VIRGIL C. SUMMER NUCLEAR STATION, UNIT NO. 1

AMENDMENT TO FACILITY OPERATING LICENSE

Amendment No. 58  
License No. NPF-12

SAFETY EVALUATION BY THE OFFICE OF NUCLEAR REACTOR REGULATION  
RELATED TO AMENDMENT NO. 58 TO FACILITY OPERATING LICENSE NO. NPF-12

FIGURE 6.2-1  
SOUTH CAROLINA ELECTRIC AND GAS COMPANY  
VIRGIL C. SUMMER NUCLEAR STATION  
OFF SITE ORGANIZATION

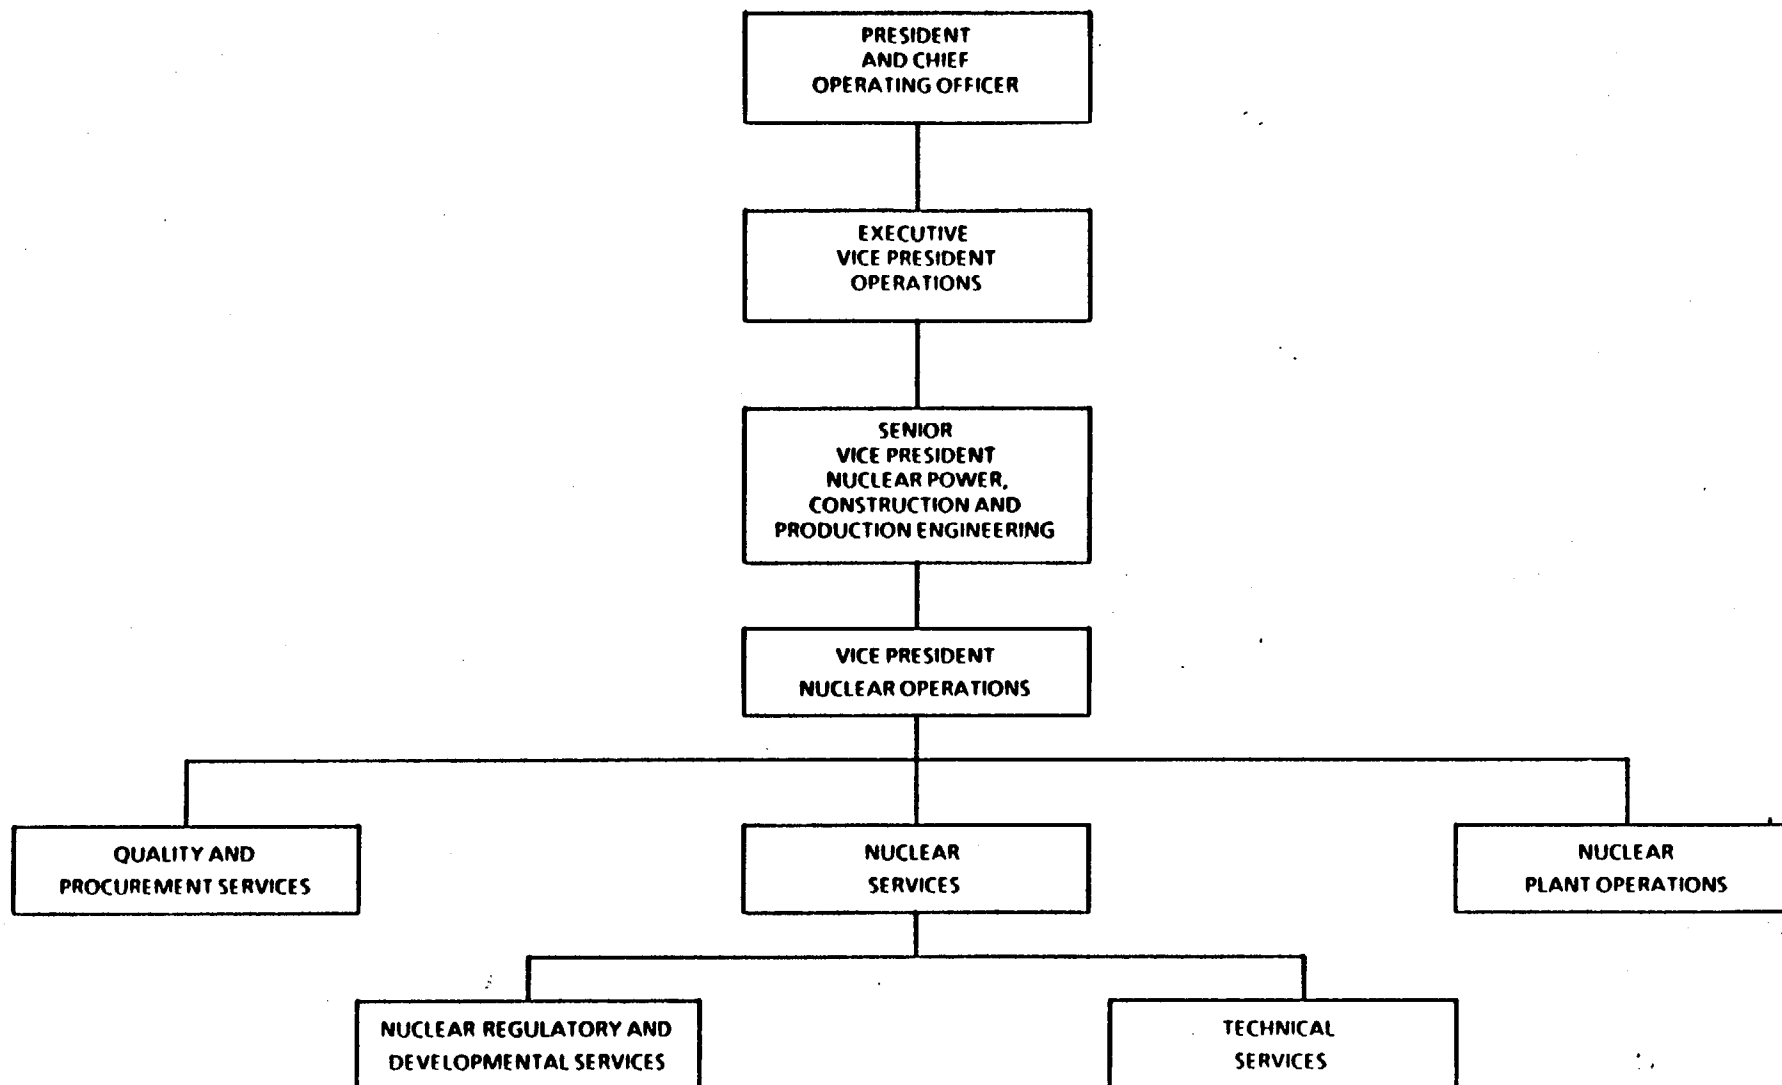
At the corporate level, the organization as shown on TS Figure 6.2-1 would be changed as follows:

- (1) The title of the Senior Vice President, Power Operations would be changed to Senior Vice President, Nuclear Power, Construction and Production Engineering. This is a title change that does not affect the organizational structure under the Vice President, Nuclear Operations and does not change his nuclear-related responsibilities. It is, therefore, acceptable.

- (2) Within the Nuclear Services Division, three group manager positions would be combined into two. The Nuclear Education and Training group and the Regulatory and Support Services group would be combined into a new Nuclear Regulatory and Developmental Services group. There are no changes in reporting relationships or functional responsibilities other than the consolidation into the one group, and no change in the overall corporate commitments. The change is, therefore, acceptable.

- (3) The Procurement Group previously located in the Nuclear Operations Department would be transferred to the Quality Services Organization, which would be retitled Quality and Procurement Services. This change would not change job responsibilities or overall organizational commitments. It is, therefore, acceptable.

The corporate level changes represent a restructuring of the corporate organization which should have no impact on the corporate support of plant operations. The changes described are shown on revised TS Figure 6.2-1. The resulting corporate organization is in accordance with the requirements of Section 13.1.1. of the Standard Review Plan, NUREG-0800, and is acceptable.

FIGURE 6.2-2  
VIRGIL C. SUMMER NUCLEAR STATION  
FUNCTIONAL ORGANIZATION

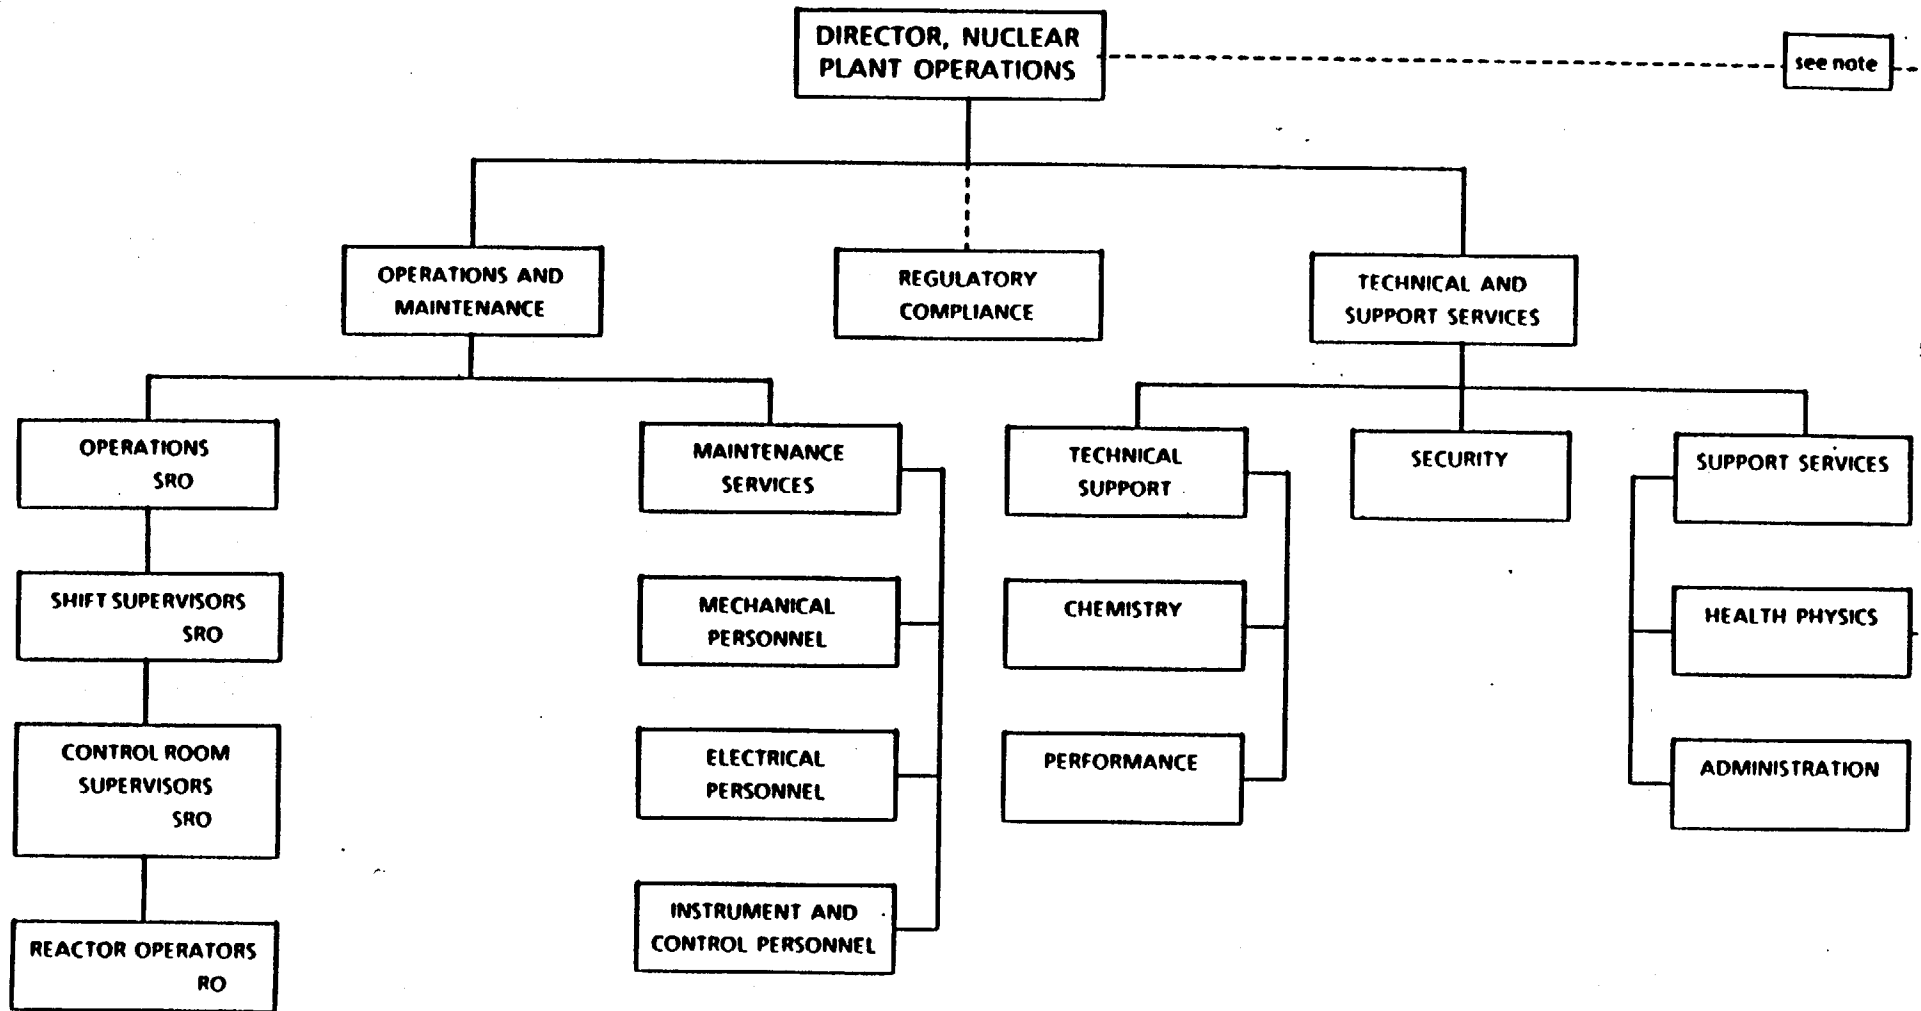
At the plant level, the organization shown on TS Figure 6.2-2 would be changed as follows:

- (1) The Security Organization previously reported administratively offsite to the Group Manager, Regulatory and Support Services, and functionally onsite to the Group Manager, Technical and Support Services. This organization would now report both administratively and functionally to the Group Manager, Technical and Support Services. This change would not affect the responsibilities or functioning of the Security Organization. The change is, therefore, acceptable.

- (2) The Regulatory Compliance group previously reported to the Director, Nuclear Plant Operations. Under the proposed organization, this group would still be located onsite and would functionally support the Director of Nuclear Plant Operations. However, it would now report administratively to the Manager, Nuclear Licensing in the new Nuclear Regulatory and Development Services group. This change should improve corporate oversight of compliance activities and is acceptable.

The station organization resulting from the proposed changes are shown on revised TS Figure 6.2-2. The changes do not represent a decrease in support to plant operations and the resulting organization is in accordance with the requirements of Section 13.1.2 of the Standard Review Plan, NUREG-0800. The proposed changes are, therefore, acceptable.
